RE: St. Lucie Unit 2
Docket No. 50-389
Technical Specification Bases Control Program
Periodic Report of Bases Changes TS 6.8.4.j.4

Pursuant to Technical Specification (TS) 6.8.4.j.4, Florida Power & Light Company (FPL) is submitting the periodic report of changes made to the St. Lucie Unit 2 TS Bases without prior NRC approval. The requirement for the periodic report was added by St. Lucie Unit 2 License Amendment 117 on July 12, 2001 and is required on a frequency consistent with 10 CFR 50.71(e) for UFSAR updates. FPL submits the 10 CFR 50.71(e) reports within six months of the completion of each refueling outage. This report covers the period from April 24, 2014, to the startup from the fall 2015 Unit 2 refueling outage (SL2-22).

**ST. LUCIE PLANT TECHNICAL SPECIFICATIONS
BASES CONTROL PROGRAM AND TECHNICAL
SPECIFICATIONS BASES**
Responsible Department: **LICENSING****REVISION SUMMARY:**

FIGURE B 2.1-1
AXIAL POWER DISTRIBUTIONS FOR THERMAL MARGIN SAFETY LIMITS

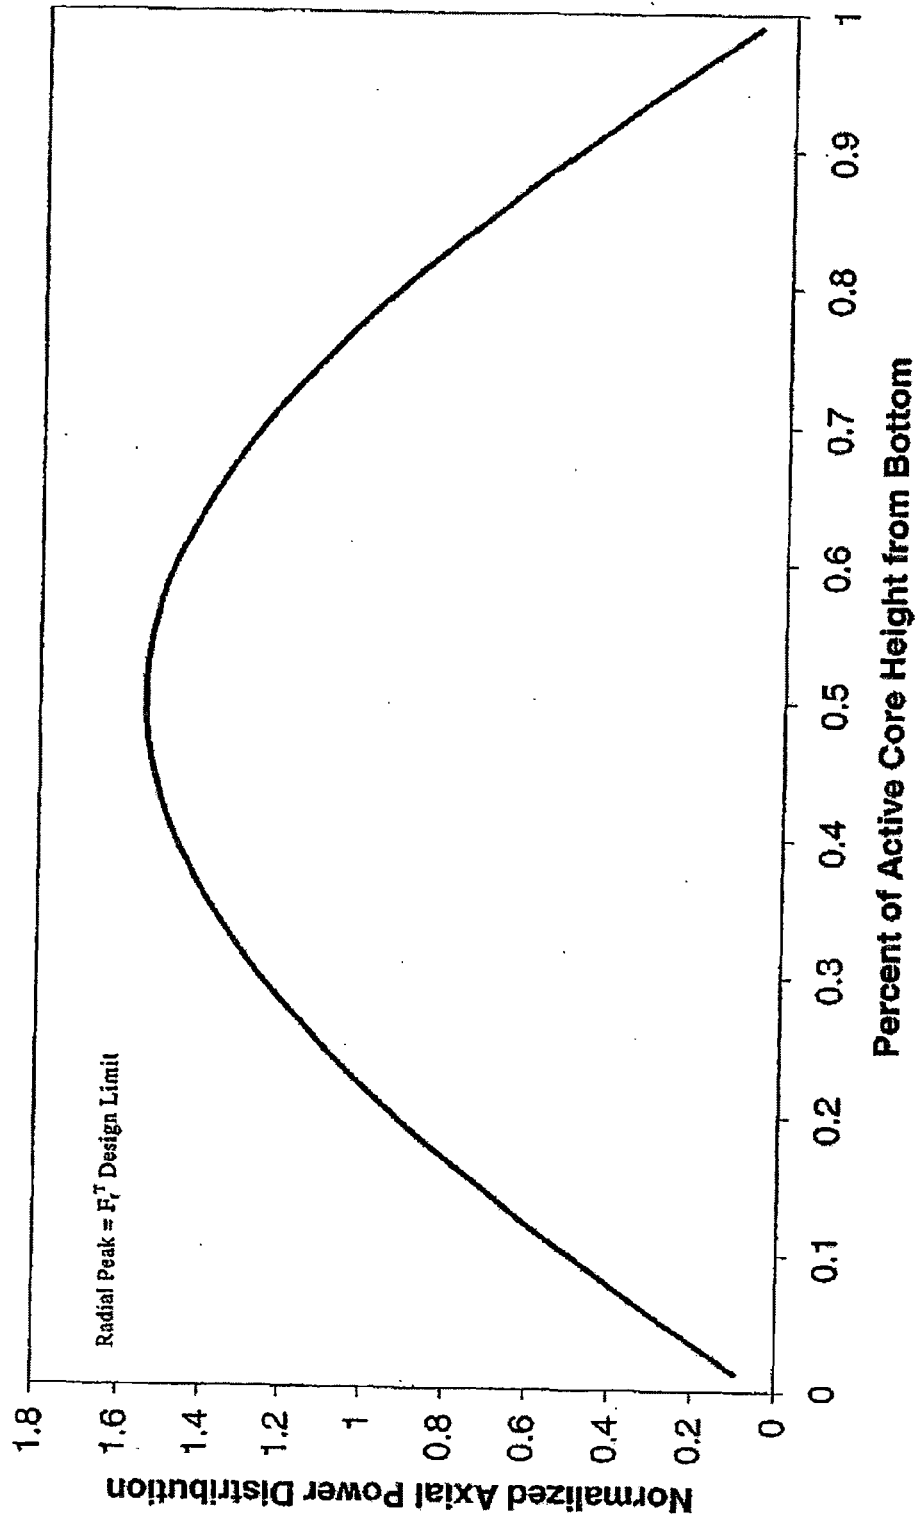
Revision 2 – Incorporated PCR 03-1249 to revise Section 2.1.1, Figure B2.1-1 and Section 2.2.1 in accordance with Tech Spec Amendment 131; LAR 2002-06; NRC letter dated 4/18/03 regarding reduction in minimum RCS flow. (M. DiMarco, 05/02/03)
